REVISED POST-DEMOLITION RISK ASSESSMENT, BOEING C-6
FACILITY, PARCEL A, LOS ANGELES, CALIFORNIA

SUBJECT: McDonnell Douglas (Boeing): Revised Post-Demolition Risk
Assessment, PCA 24120 Site Code 400627/50 MPC 44

POST-DEMOLITION RISK ASSESSMENT, BOEING C-6 FACILITY,
PARCEL A, LOS ANGELES, CALIFORNIA

SUBJECT: Mc Donnell/Douglas (Boeing): Post Demolition Risk Assessment
PCA 24120 Site Code 400627/50 MPC 44

- a) a histogram plot of field soil data to show distribution*

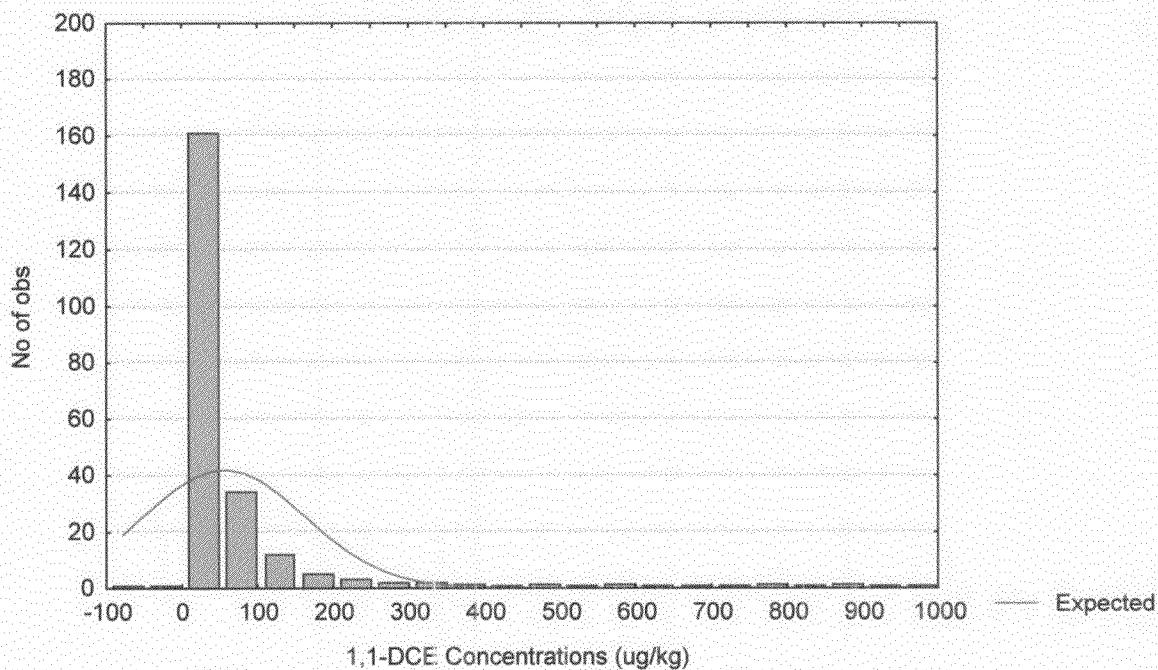
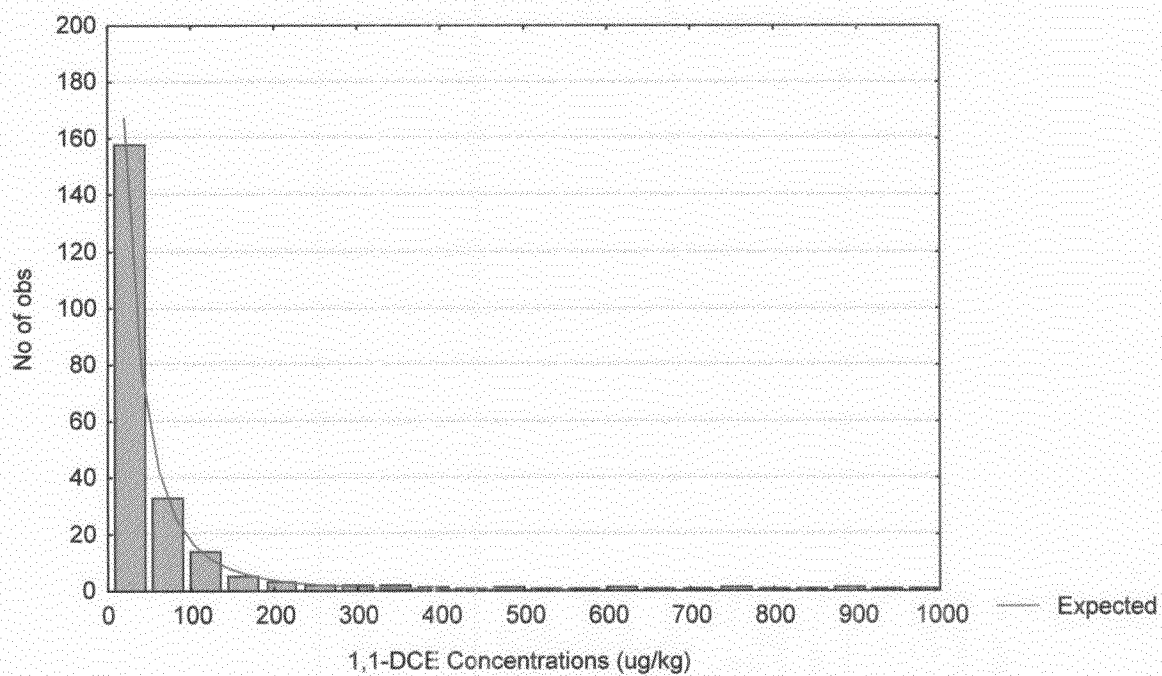
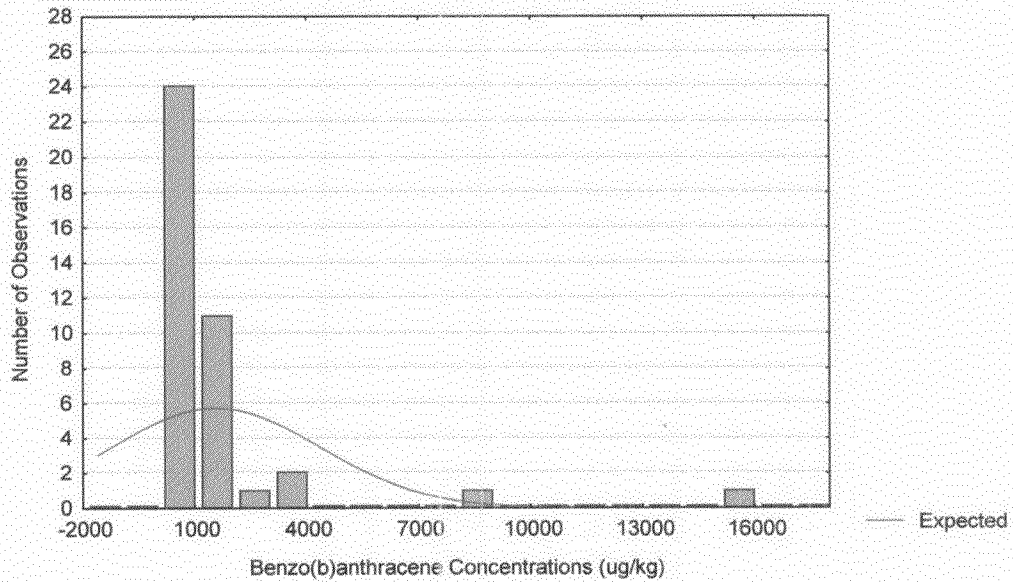
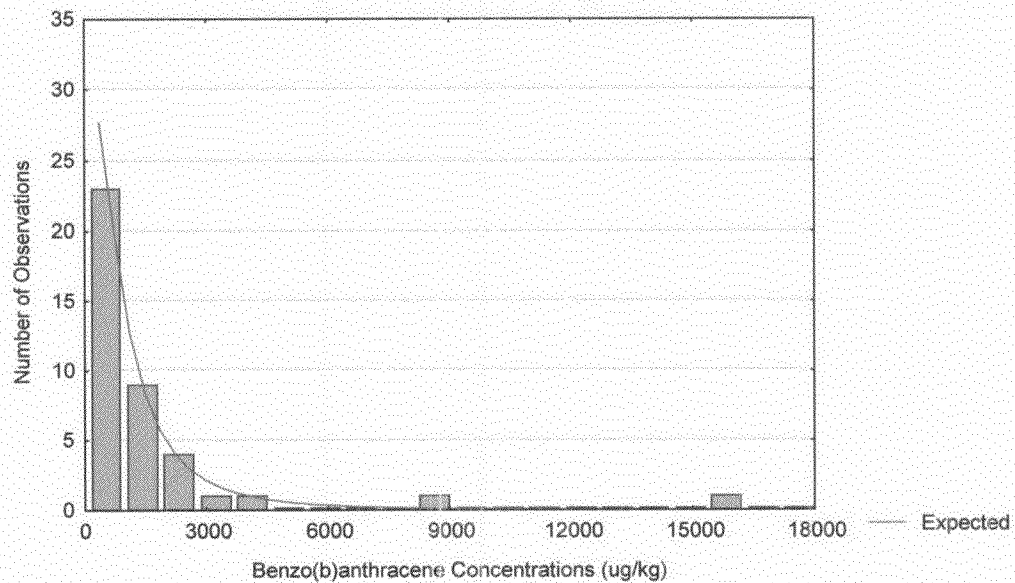
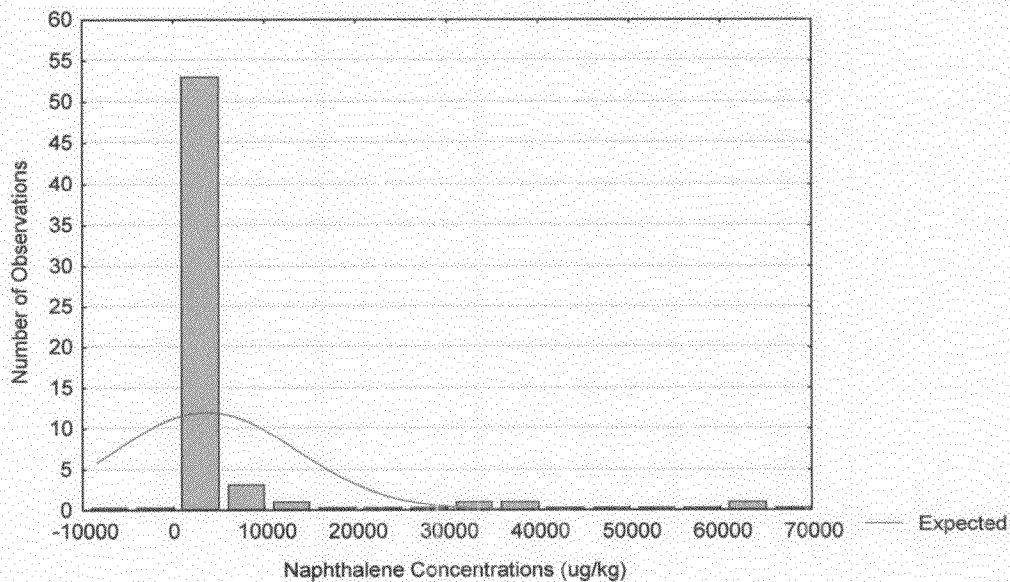
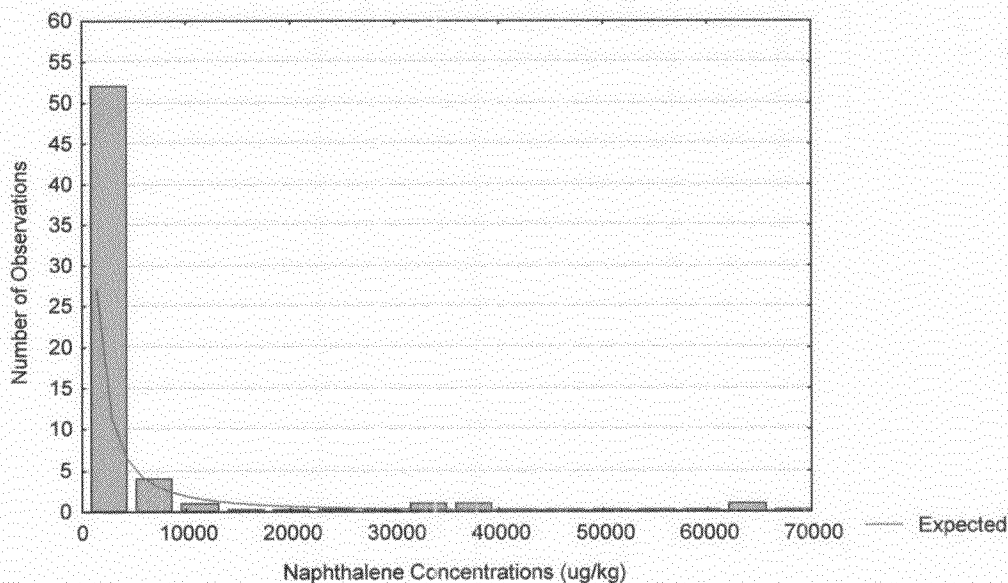
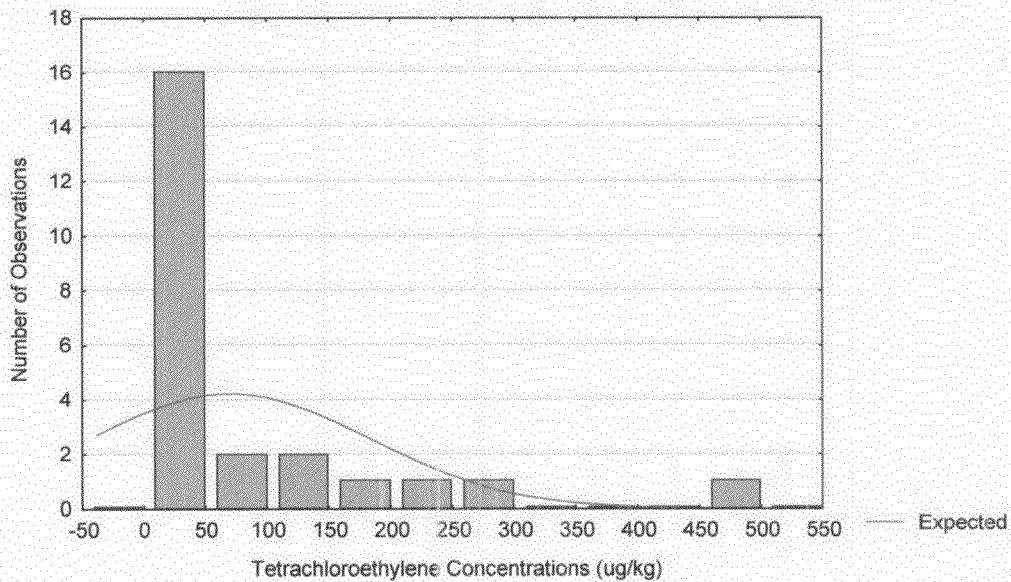
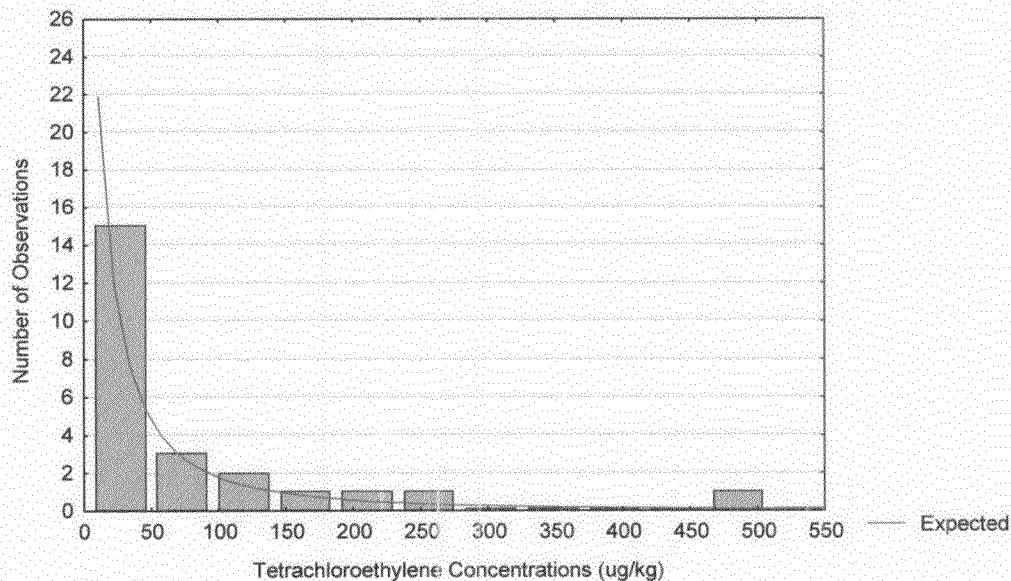
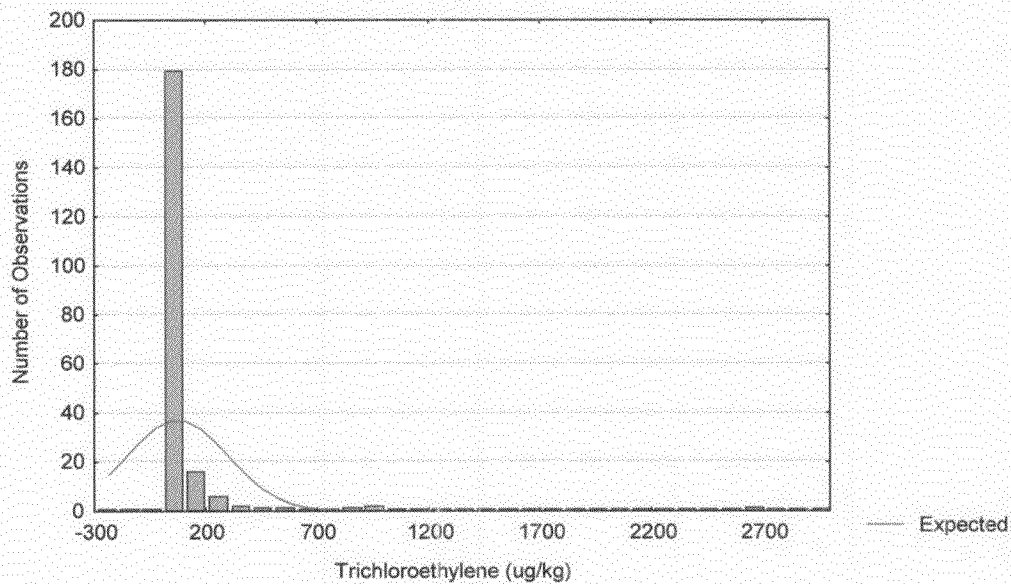
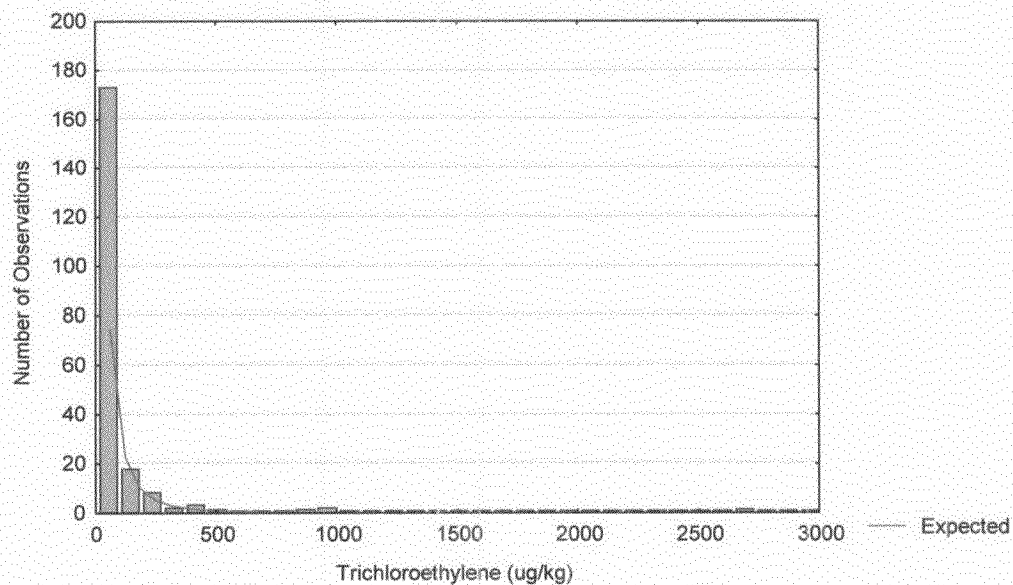
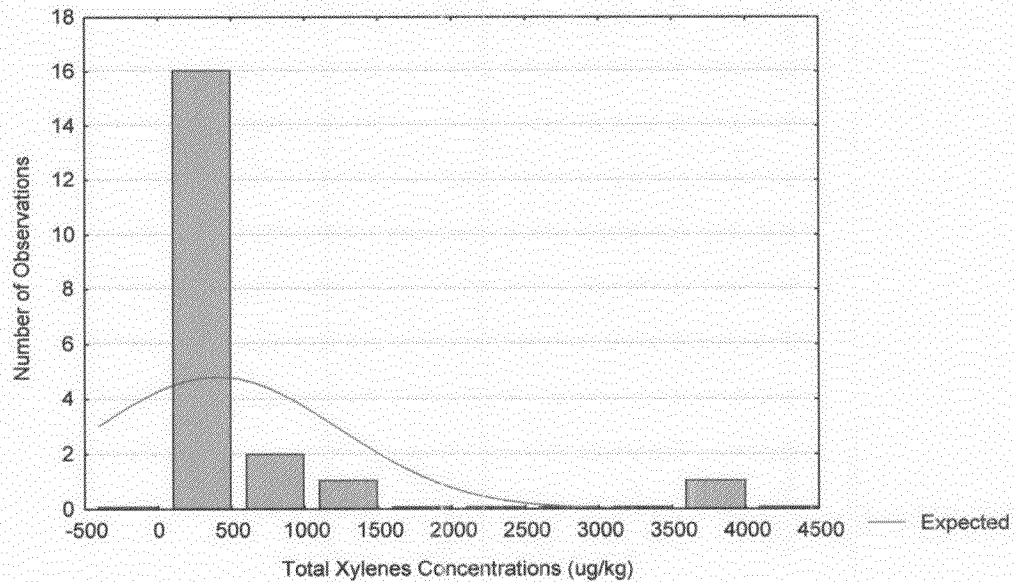
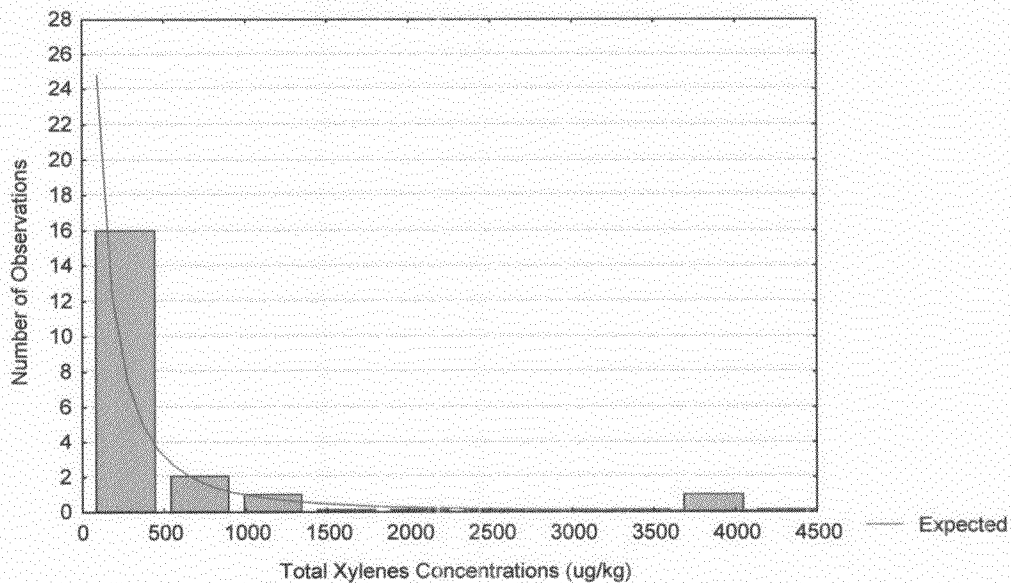
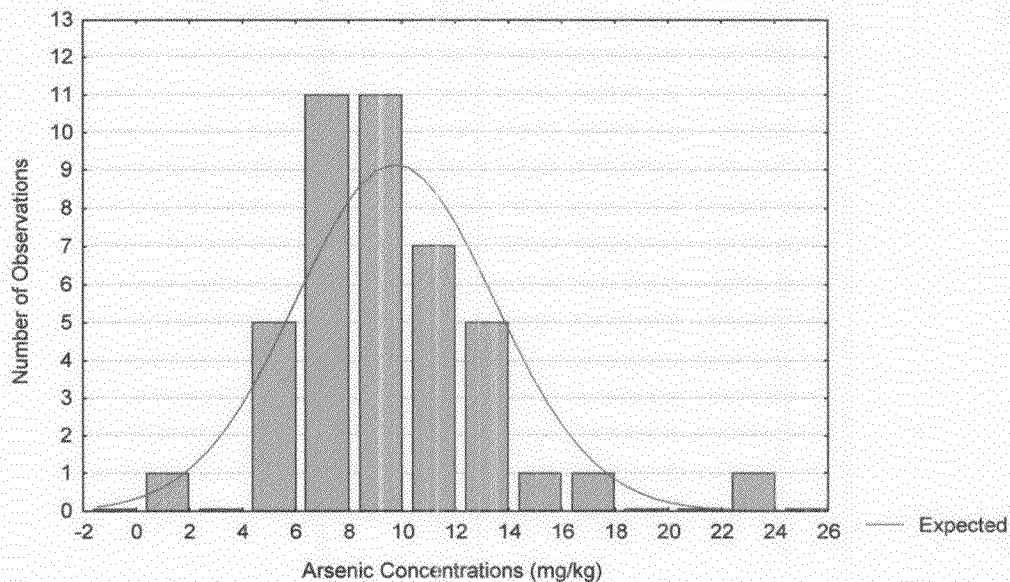
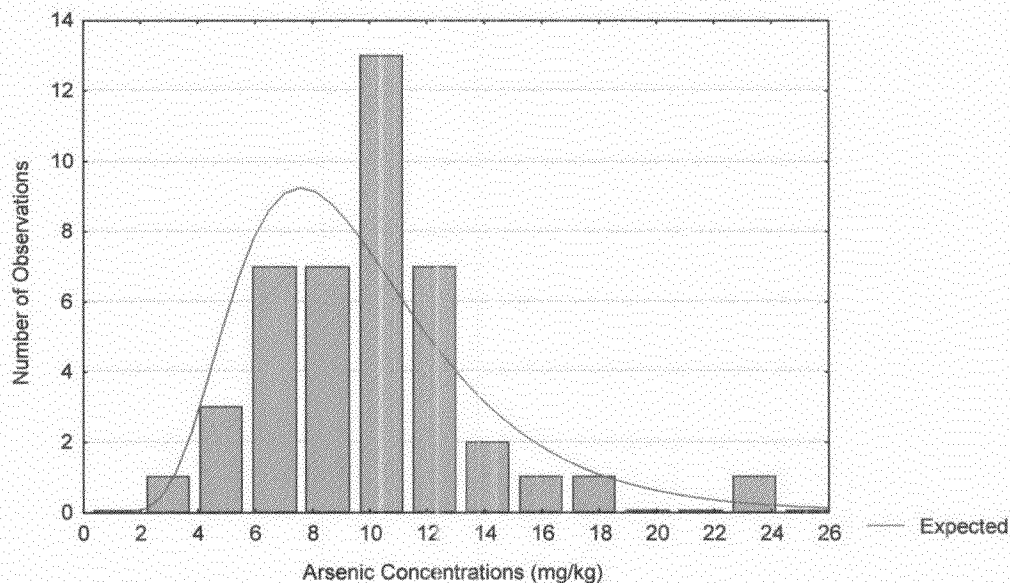
Comment 1: To evaluate the chemical concentration data, as discussed, we require statistical soil data for the following constituents of potential concern (COPCs) in Table 2-1 (page 2-10): 1,1-dichloroethylene, aroclor 1248, aroclor 1260, benzo(b)fluoranthene, dibenzo(a,h)anthracene, naphthalene, tetrachloroethylene, trichloroethylene, total xylenes, and arsenic. Please provide us with the following data for the COPCs listed:

- a) a histogram plot of field soil data to show distribution.*
- b) the D'Agostino's test results to show either the normal or log-normal distribution.*

Response: The data set used in the derivation of exposure point concentrations includes over 200,000 records as presented in Supplemental Books 1-5 of the March 6, 1998, version of the Post-Demolition Risk Assessment (PDRA). Integrated has performed numerous statistical evaluations of the data set prior to the development of the PDRA. The following addresses the RWQCB requested statistical analyses.
